# City Planning Department

To: Cranston City Plan Commission  
From: Doug McLean, AICP, Principal Planner  
Date: October 1, 2021  
Re: Dimensional Variance Application for 481 Atwood Avenue - Signage

# PROPOSED MONUMENT SIGN REQUIRING VARIANCE

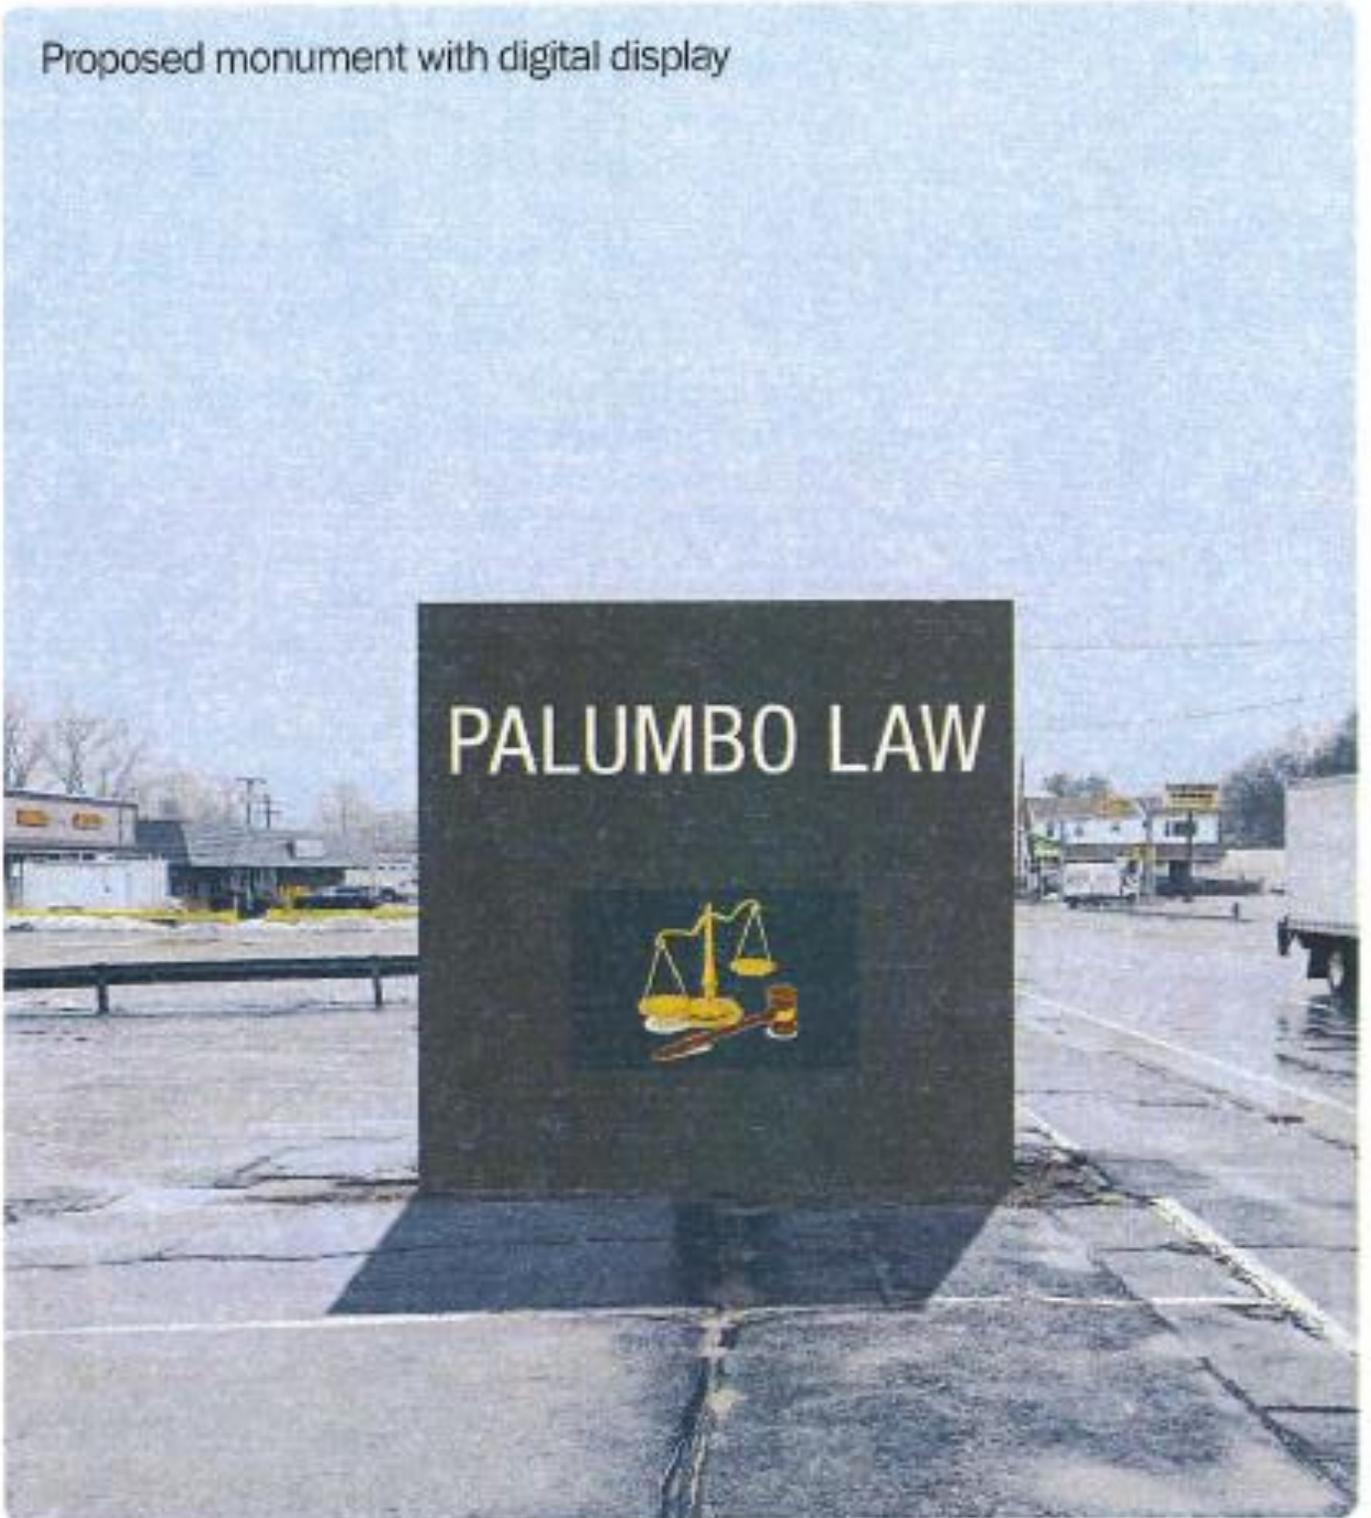
- Staff provided pre-application comments/questions to the applicant regarding concerns of the sign's size as well as the inclusion of an LED/animated component and suggested that the applicant may wish to address reasonable limitations of the animated component of the sign, such as:

- Will animated sign include moving images or static images?
  - If static images, how frequently will images change?
  - Will the application place an illumination (brightness) limitations on the animated component of sign?

- Will the brightness of the animated component of sign be adjusted during day vs. night?

Staff would note that the applicant did not include any descriptions or limitations on the item noted above regarding the animated component of sign.

- Based on the fact that this application includes an LED/ animated sign that does not set any limitations on type, frequency, or brightness of animations, staff finds that the proposal is not consistent with the Cranston Comprehensive Plan which established a desire to minimize negative visual impacts.

# PROPOSED MONUMENT SIGN DIMENSIONS

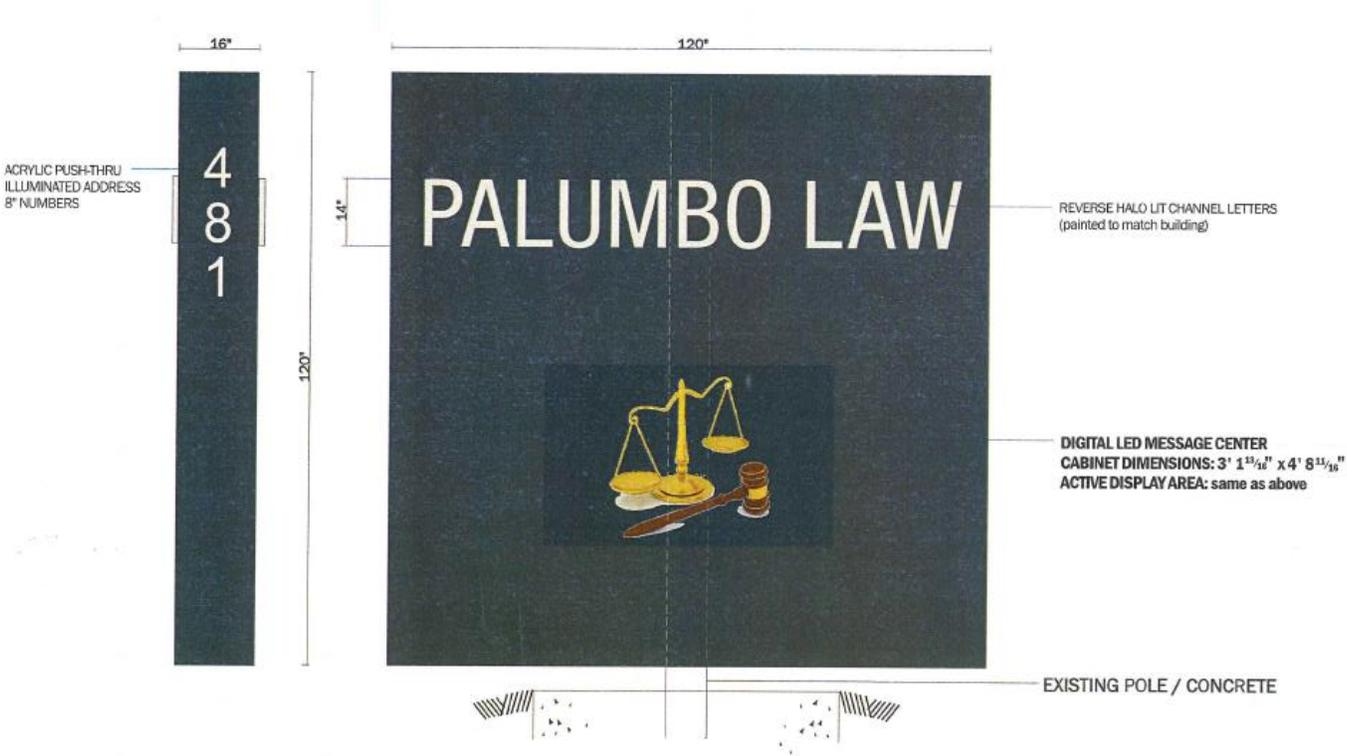
- Monument sign is 10 ft X 10 ft for a sign face of 100 sqft per side and a total sign area (both sides of sign) equating to 200 sqft. The maximum sign area in a M-1 zone is 50 sqft.

- Monument sign is 10 ft tall. The maximum sign height in a M-1 zone is 4 feet.
  - Monument sign is 0 ft from property line. The minimum sign setback in a M-1 is 2 feet from property line.

- Monument sign will include a LED/animated display area that is approximately 3 ft x 4.75 ft in size on both sides of the sign. This totals approximately 30 sqft of LED/animated display area. Such type of signs are not allowed per the Cranston zoning code.

# SITE PLAN (proposed sign circled in red)

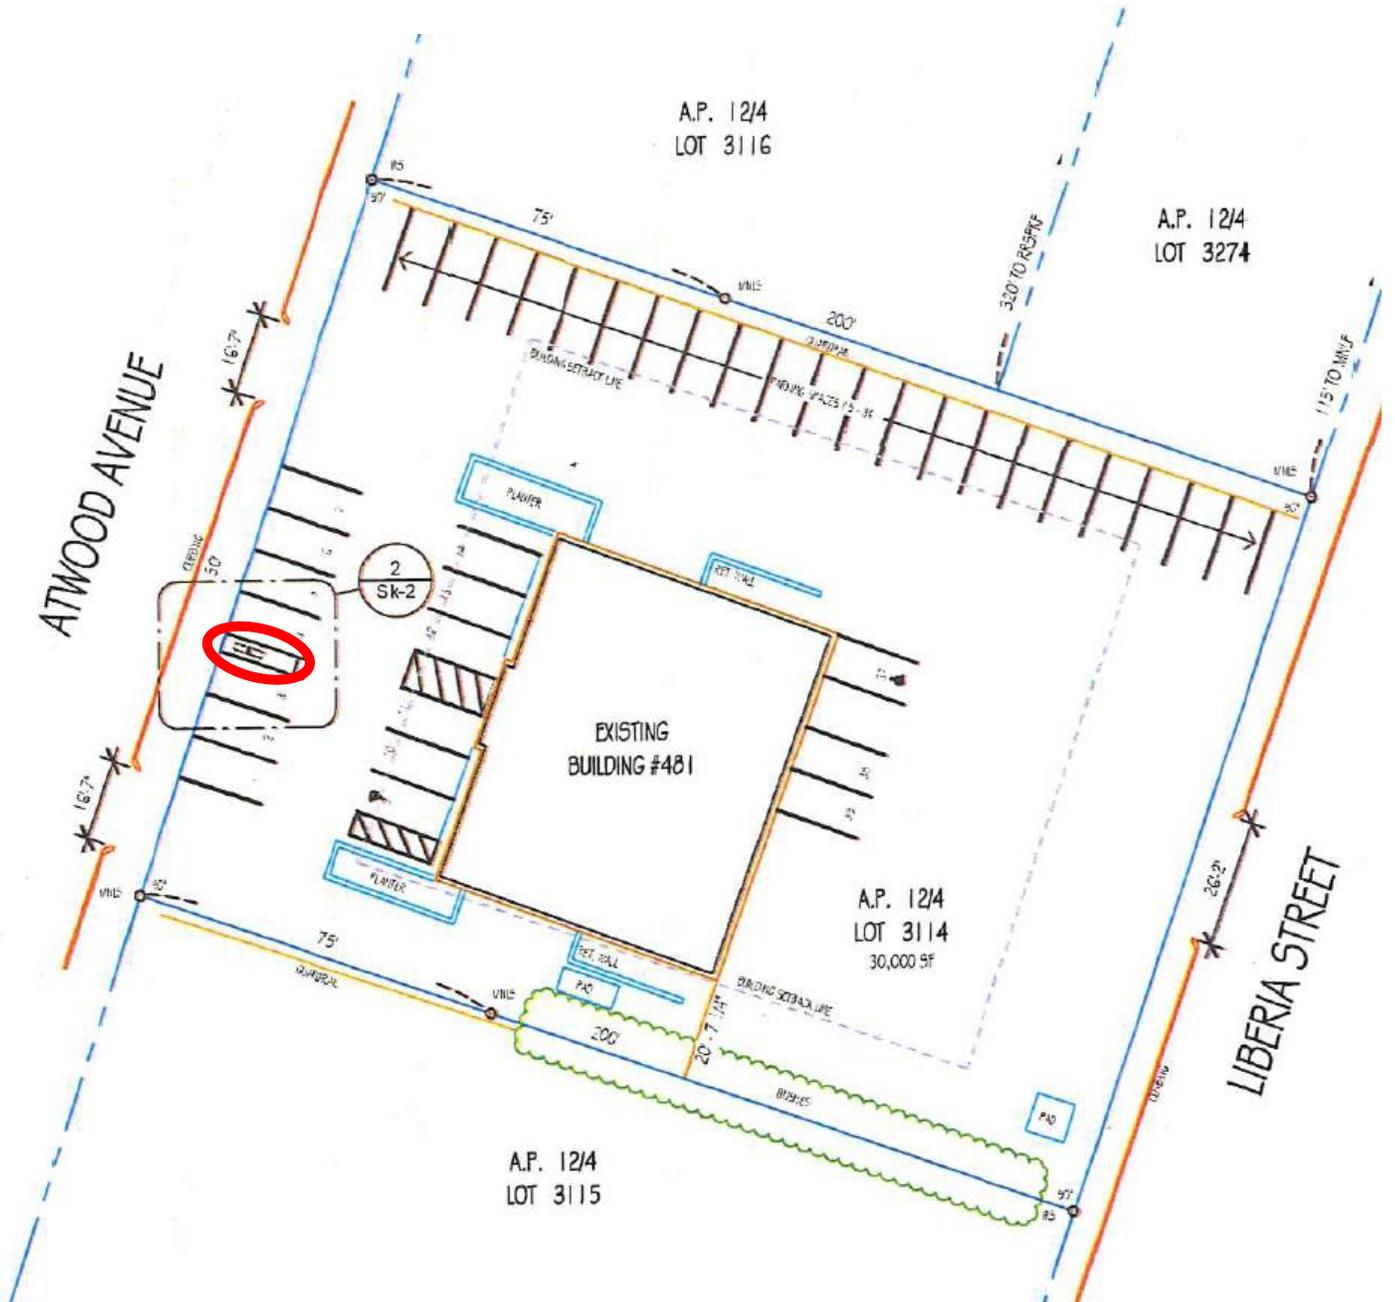
- The site has 2 curb cuts along Atwood Avenue to provide primary access to the property. The proposed monument sign will be located between the 2 curb cuts and will be approximately 35 feet from each. Based on the sign's massing, height, and zero (0) setback from the property line/sidewalk, as well as the proximity to the curb cuts, staff has concerns that the proposed sign may present a safety concern with regard to blocking sightlines for vehicle safety. **The City's Traffic Engineer reviewed the proposal and provided comment that the application did present safety concerns regarding vehicle sightlines.**
